Duke Power Company
Oconee Nuclear Station

Proposed Technical Specification Revision
Oconee 3, Cycle 10

No Significant Hazards Consideration Evaluation
for Oconee Unit 3, Cycle 10 Reload

Oconee Unit 3, Cycle 10 Reload Report

Figure 8-1

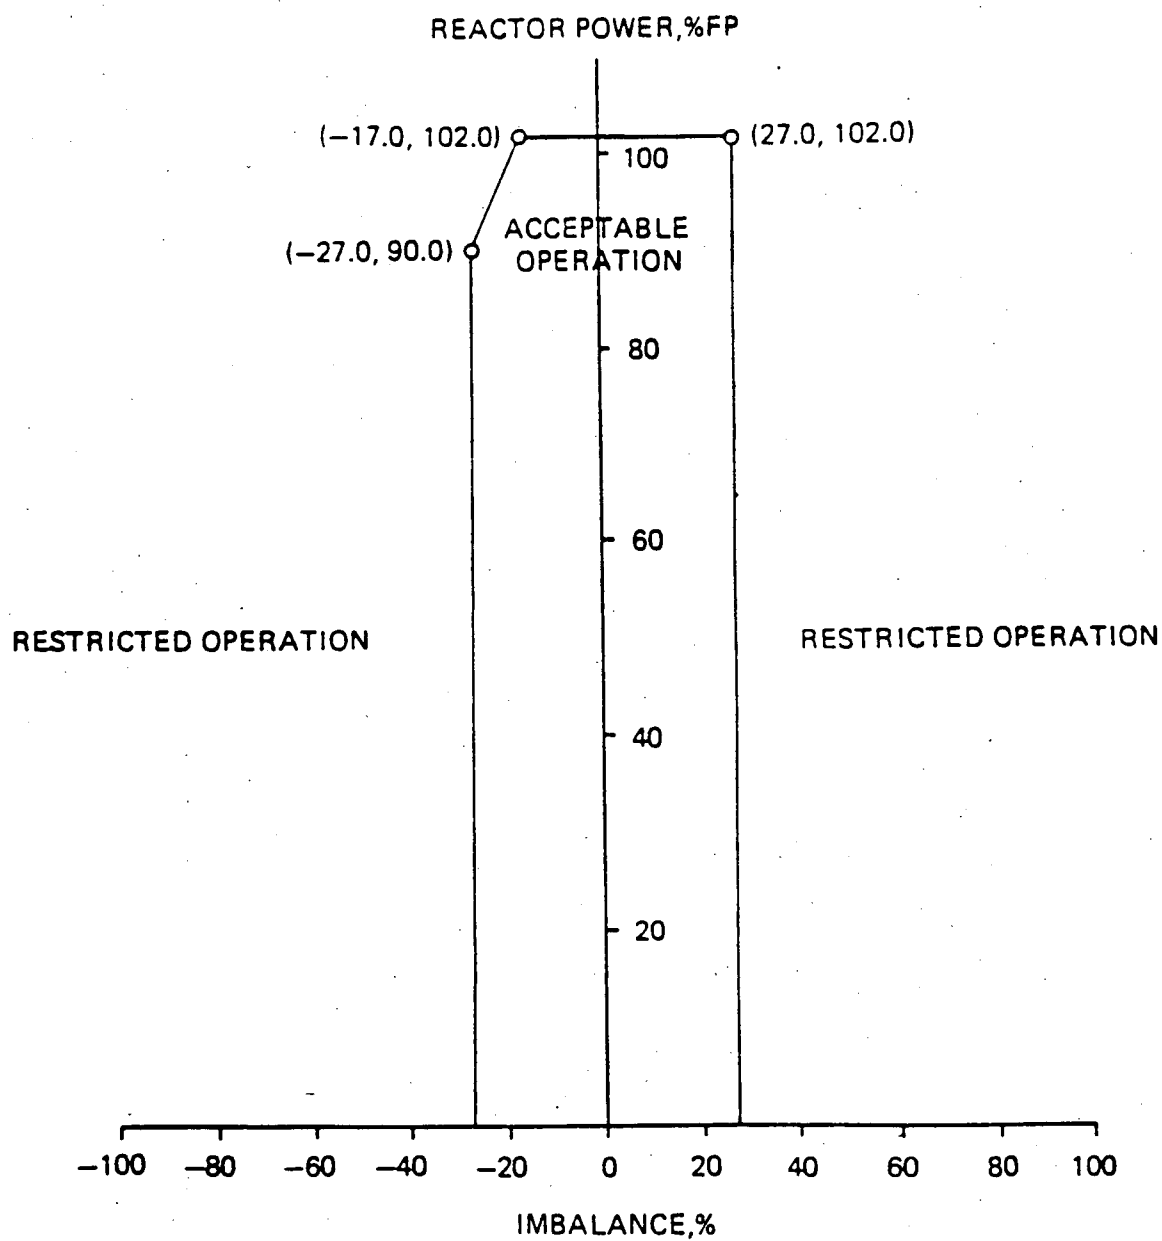
8. PROPOSED MODIFICATIONS TO TECHNICAL SPECIFICATIONS

The Technical Specifications have been revised for Cycle 10 operation in accordance with the methods of Reference 10 to account for minor changes in power peaking and control rod worths.

1. The operating limits on rod index and axial power imbalance were developed in accordance with the LOCA linear heat rate limits discussed in Chapter 7.
2. Due to the lower worth of the gray APSRs, operational limits for the Group 8 control rods are not required for Cycle 10. Administrative position and maneuvering limits for the APSRs, however, will be utilized to ensure adequate fuel performance during Cycle 10 operation.
